EEG-70

**EEG OBSERVATIONS OF THE MARCH 1998
WIPP OPERATIONAL READINESS REVIEW AUDIT**

Environmental Evaluation Group
New Mexico

May 1998

Figure 1. WIPP Disposal Horizon

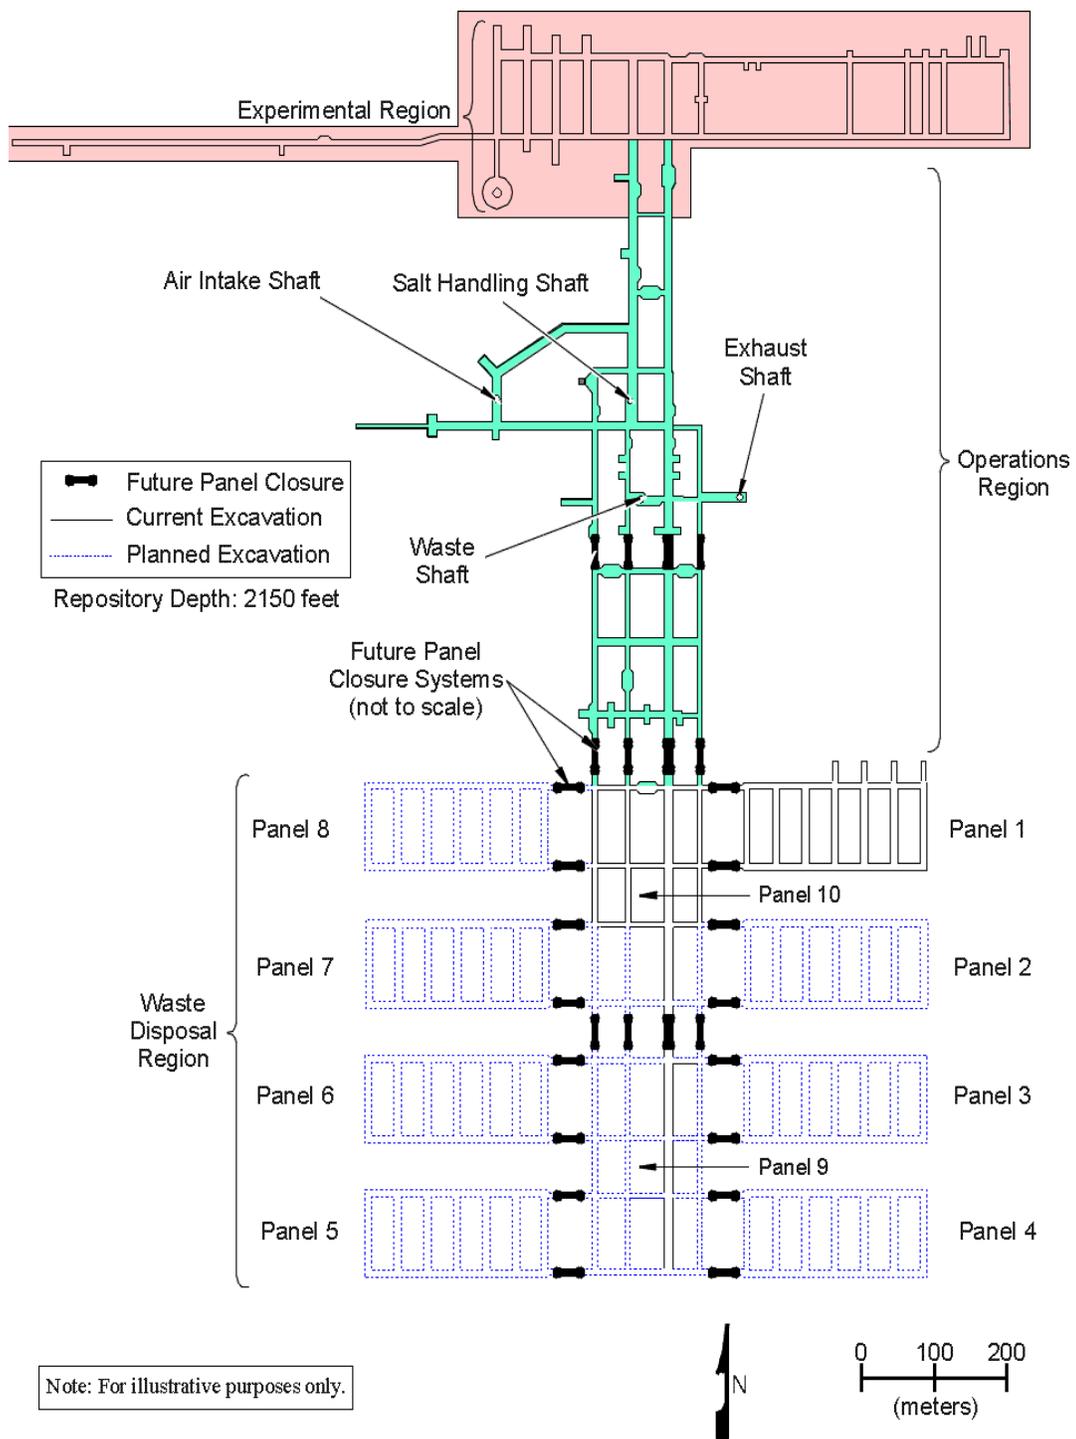
From 1982 to 1988, WIPP rooms and drifts were excavated as shown in Figure 1. Within a few years of the March/April 1983 excavation, Site and Preliminary Design Validation (SPDV) rooms in the experimental region began to show signs of deterioration, and within 8 to 9 years two major roof falls occurred in the northern experimental area. In addition, roof falls occurred in heated rooms A-1, A-2, and A-3 in the experimental region, designed to accelerate the closure process. By design, these rooms were not maintained as repository rooms, but rather were excavated for test purposes. Without remedial efforts, a geotechnical panel concluded that repository rooms would have an expected life of seven to eleven years.

Roof stability is insured by routine maintenance and roof-support systems. Unlike the experimental rooms, the repository rooms have been maintained and equipped with appropriate roof-support systems. Although panel 1 was excavated between 1986 and 1988 and is experiencing age-related closure, the WIPP plans to use this panel for initial waste emplacement. To insure worker safety, closure rate data are tracked and analyzed to predict unstable roof conditions. Increased closure rates may require that potentially unstable areas be abandoned.

Assuring a high level of safety in panel 1 is not a straightforward process. Unlike newly excavated areas, the advanced stage of panel 1 salt creep requires constant stability monitoring and roof maintenance. It will take at least four years to fill panel 1 considering current CAO emplacement plans (US DOE/CAO 1997a). Once rooms or drifts are filled with waste, roof maintenance is not possible. Radiological confinement depends on containers surviving a roof collapse or brattice-cloth barriers remaining intact (Westinghouse 1997b, Section 5.2.3.11). If the anticipated delivery and emplacement schedules are further delayed, then the potential for roof falls will increase.

To “assure stability” and safety, it is best to abandon panel 1 and mine a new panel as soon as all permitting processes are complete. The new panel should be positioned at a sufficient distance from panel 1 to minimize the detrimental effects associated with load transfer from panel 1 toward the new panel. To improve the long-term stability of E140, it is important to modify the excavation geometry and possibly to increase barrier pillar widths for future entries and panels.

Figure 2. Relative Positions of Air Regulator Louvers in Waste Room Bulkheads

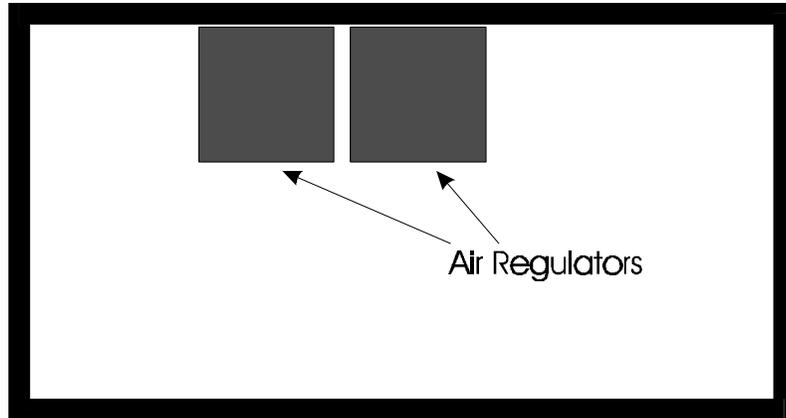
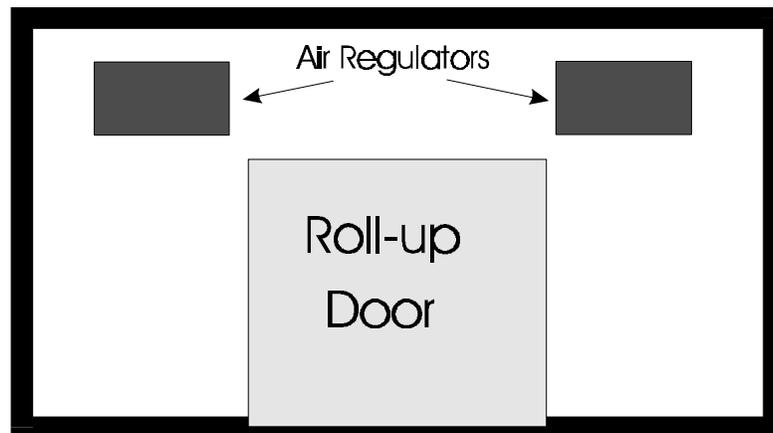
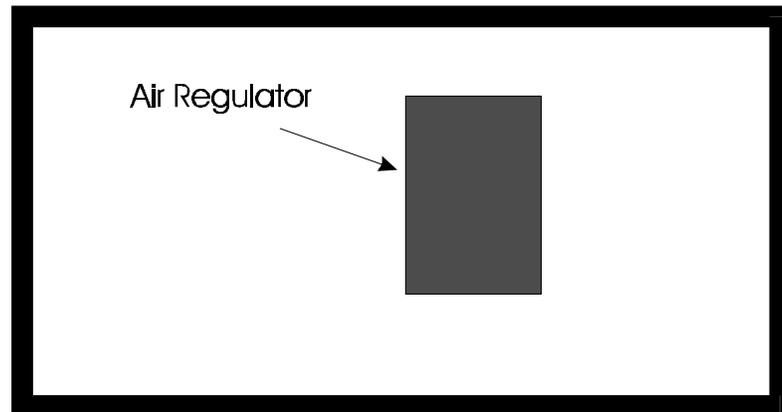
Initial waste emplacement is planned to occur in panel 1, room 7, and a bulkhead is located at the north end of this room in the S1600 drift. The bulkhead has a large, centrally located roll-up door and two sections of louvered openings for airflow control. The panel 1, room 7 design is not the same as panel 1, room 1 or the typical design shown in the 1997 WIPP SAR (Figure 2).

During the drill, the S1600 drift bulkhead roll-up door was inadvertently left open. In this configuration, the bulkhead could not control airflow and most of the airflow would by-pass the radiation effluent monitors located behind the exhaust louvers. This abnormal configuration was identified by the ORR team as a violation of the required facility configuration and classified as a “pre-start” finding. The ORR team considered the failure of workers to confirm the operational configuration as the root cause of the problem. The remedy was suggested to be adherence to the facility procedures.

Roll-up doors in a radiological confinement barrier increase the likelihood that room air flow will not be properly regulated and that radiation monitors may be by-passed. A simple solution is to remove the roll-up door and seal the opening, or perhaps permanently secure the door.

An additional concern is the non-standard airflow characteristics through bulkhead louvers where radiation monitors are located. For radiation monitors to function properly, the airflow characteristic around the monitor sampling probe must be carefully established (ANSI 1969). If the number or size of exhaust louvers is changed, then these airflow characteristic will change and necessitate additional radiation monitor operational testing. A standard bulkhead design without a roll-up door, and with standard location and sized exhaust louvers, would make airflow characteristics around the radiation monitor sampling probe more predictable.

Recommendation 3: A standard waste-room bulkhead should be designed and used to insure that waste-room exhaust airflow can be properly monitored and radiological confinement requirements can be satisfied. The WIPP Safety Analysis Report should be amended accordingly.
